CNRO-2004-00026

SUBJECT: Request for Alternative ANO1-R&R-006 -
Proposed Alternative to ASME Weld Examination Requirements for
Repairs Performed on Reactor Vessel Head Penetration Nozzles

Arkansas Nuclear One, Unit 1
Docket No. 50-313
License No. DPR-51

**RESPONSE TO NRC REQUEST FOR ADDITIONAL INFORMATION
(REVISED 4/30/04)**

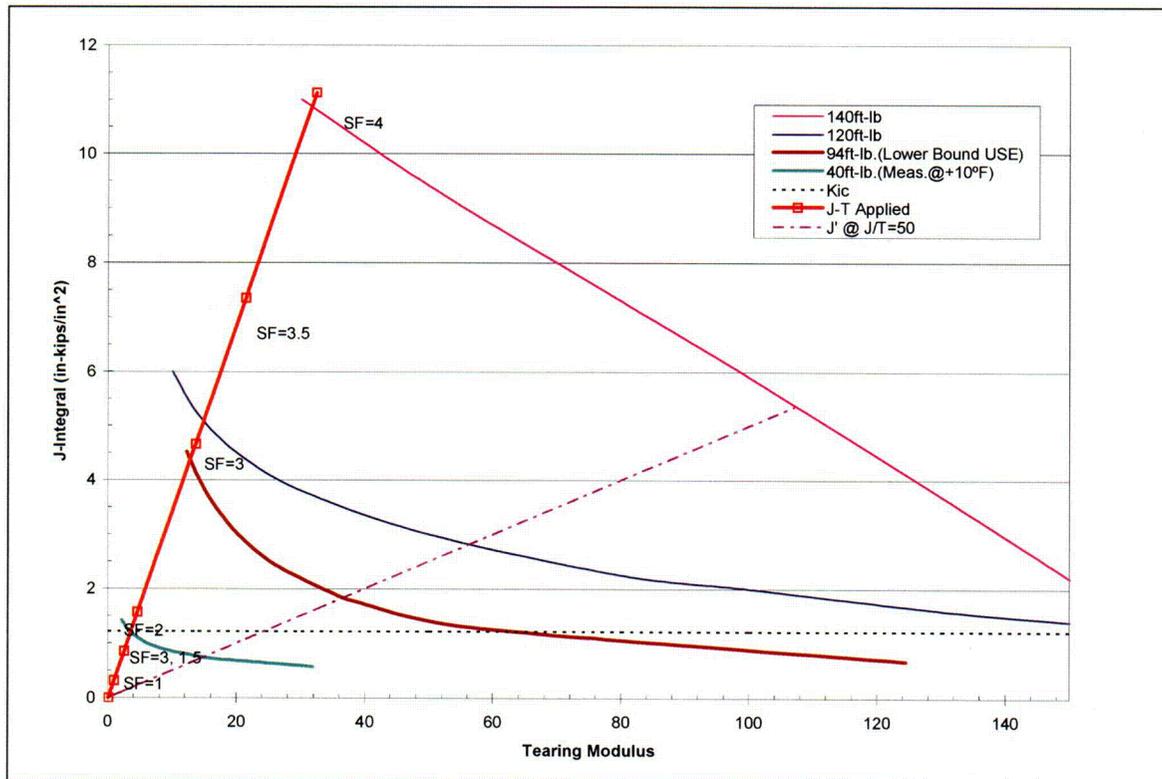
- 1a. Methodology - Discuss the steps of elastic plastic fracture mechanics (EPFM) approach; discuss the applicability of the EPFM for the ferritic reactor vessel head material in the flaw evaluation; and provide references.

- 1c. Results - Discuss the preliminary results in terms of safety factors, J applied, and J material values; and flaw growth.

For the EPFM analysis, the material toughness determination was made using accepted methods as described in detail in the enclosed technical report. The method used to estimate the material fracture toughness behavior followed the guidance provided by the NRC.⁵ The Charpy upper shelf energy (USE) for the ANO-1 RPV head was estimated using an accepted method as delineated in the enclosed technical report. The method to estimate the applied J-integral from LEFM determined SIF (K) followed the guidance in Appendix K of ASME Section XI. This is an acceptable method based on general fracture mechanics principles.⁶ The applicability of the EPFM method was demonstrated using the prescribed criterion from Appendix H of ASME Section XI. Though Appendix H is for evaluating ferritic piping, the screening criteria are generic to fracture mechanics analysis and, hence, are applicable to the current evaluation.⁷ The details are presented in the enclosed technical report. The screening criteria demonstrate EPFM to be a valid method for determining the flaw instability behavior at the operating temperatures. The details of the EPFM method used in the evaluation are described in the enclosed technical report. The results from the EPFM method is presented in Table 2 and graphically shown in Figure 1.

The results of the EPFM analysis demonstrate that proposed safety factors of 3.0 on primary stresses and 1.5 on residual stresses (indicated by the point labeled "SF = 3, 1.5" in Figure 1) provide adequate margin against flaw instability. From Table 2, the J value at instability for the ANO-1 RPV head material is found to be 4.4 in-kip/in², whereas the J value at the proposed safety factors is 0.853 in-kip/in². The margin against the instability of the postulated flaw (fully cracked J-prep) is 5.16 (4.4/0.853). Therefore, the proposed safety factors provide adequate assurance that the structural and leakage integrity of the RPV head at ANO-1 is maintained. The formulation of the proposed safety factors was based on a review of the pertinent sections of the ASME Code and supporting information from the literature. This effort is described in the enclosed technical report. Provided below is a summary of the information gleaned from this review, which supports the proposed safety factors.

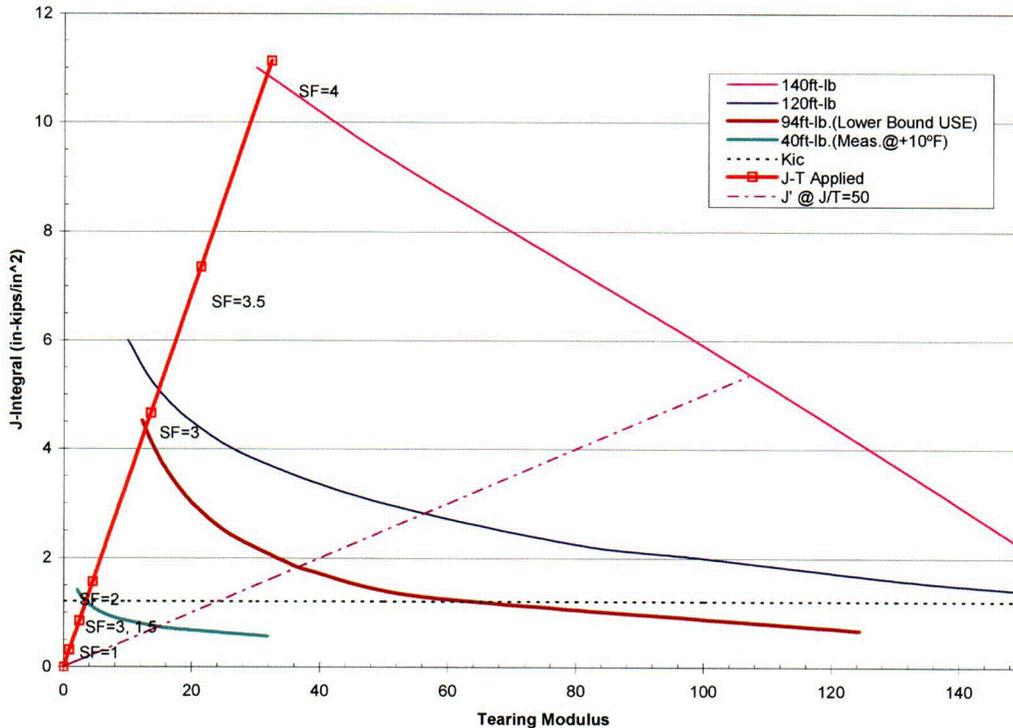
- 1d. Preliminary Conclusion - Entergy needs to make a preliminary conclusion regarding whether the postulated flaw in the J-groove weld remnant will affect the structural integrity of the ANO-1 reactor vessel head.

stress) is shown in blue font. As can be seen from Table 3 the applied “J” for the proposed safety factor is considerably lower than the “J” at instability (0.853 vs. 4.4). This indicates that sufficient margin against instability exists for the proposed safety factor. This is also observed in the graph presented in Figure 32.

The standard J-T instability analysis approach, described in Appendix K of Reference 8, shows that instability is reached when the material J-T curve intersects the applied J-T line. In Figure 32 this occurs at a “J” value of 4.4 in-kip/in². It also seen in Figure 32, that the extremely low value for USE of 40 ft-lb indicates that sufficient margin against instability is assured for the proposed safety factor. The instability point for the extremely low USE is at the intersection of the LEMF material toughness (K_{Ic}) line. In addition the Charpy data presented in Figure 27, showed that the data at +10 °F was in the lower

Using the results from the EPFM analysis, Table 3 and Figure 32, it is observed that the proposed safety factor (3.0 on primary stress and 1.5 on the residual stress) provides sufficient margin against instability. In fact the margin is a factor of 5.16 (4.4/0.853) against instability. Inherent in this calculation are conservatisms associated with the stress analysis (no consideration for stress reduction due to the new repair weld) and the lower bound USE used to determine the material toughness. Therefore, the analysis presented herein clearly demonstrates that the proposed safety factor will provide sufficient margin against instability for the postulated crack (entire J-prep assumed cracked).

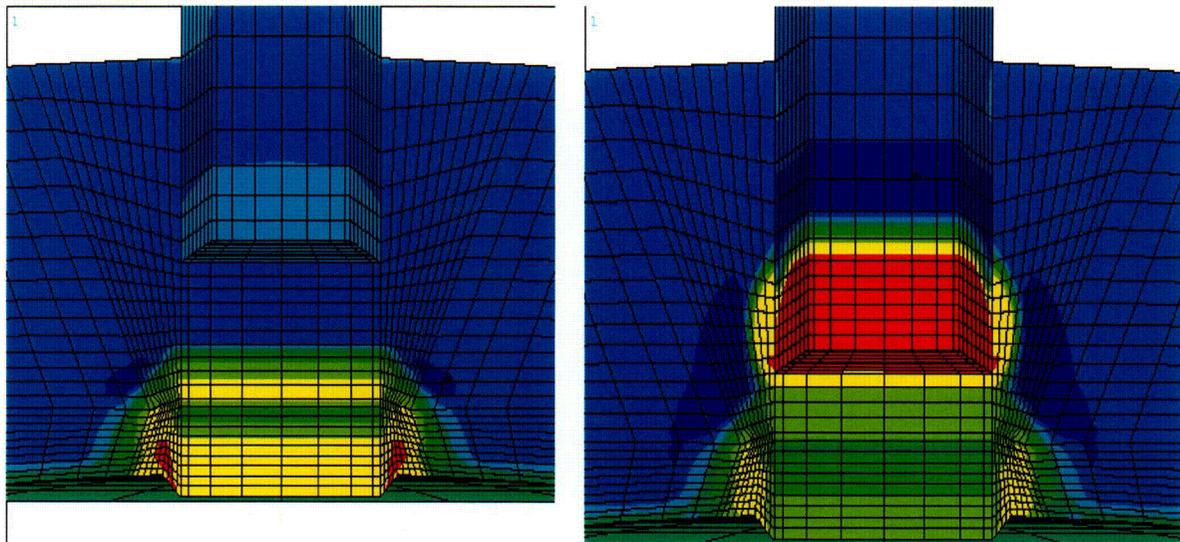
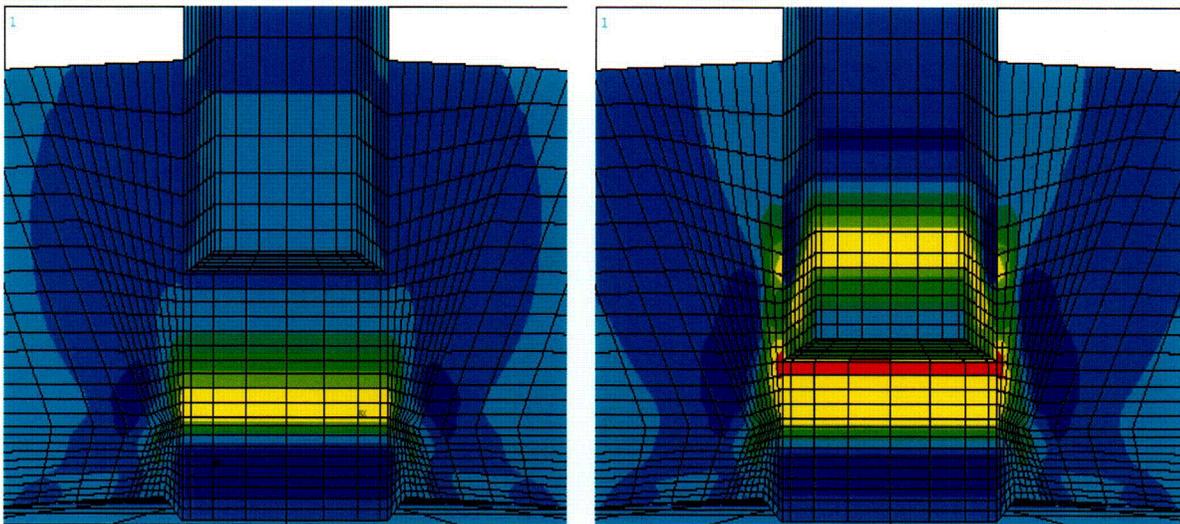
- 1) *The discussion of the analysis results and that of the ASME Code review and its applicability for the postulated J-groove weld remnant are presented on pages 48 through 52 of the technical report (Enclosure 3).*
 - 2) *The conclusion, based on the analytical effort, is presented on pages 53 and 54 of the technical report (Enclosure 3).*
2. Entergy needs to make a preliminary conclusion regarding whether the nozzle repair proposed in Request ANO1-R&R-006 will affect the reactor vessel head in maintaining the structural integrity and leakage integrity of the reactor coolant system.

The evaluation of the new repair weld impact on the remnant J-groove weld is presented on pages 46 and 47 of the technical report (Enclosure 3). Conclusions are provided on pages 53 and 54 of the report.

The comparison presented in Figure 33, for the hoop stress shows that the stress distribution at the J-groove weld remnant is softened by the installation of the new repair weld. Note that the high stress region (red color) at the J-groove weld corner prior to the installation of the new repair weld has disappeared and become softer (yellow color). This indicates that the installation of the new repair weld reduces the magnitude of the prevailing stress distribution, in the vicinity of the J-groove weld remnant compared to those prior to the installation of the new repair weld. A similar observation is evident from the comparison presented in Figure 34.

Therefore, it is concluded that there is no significant detrimental (increase in stresses) impact on the J-groove weld remnant upon the installation of the new repair weld. On the contrary a beneficial (stress reduction) impact is observed. However, the stress analysis used to provide the stress distribution for the finite element LEFM analysis did not consider the installation of the new repair weld. Hence the stress distribution used in the finite element LEFM analysis is an upper bound stress distribution. This provides added conservatism in the determination of the SIF; that is the estimated SIF is larger than those (SIF) that would be obtained from a simulation which realistically accounted for the full
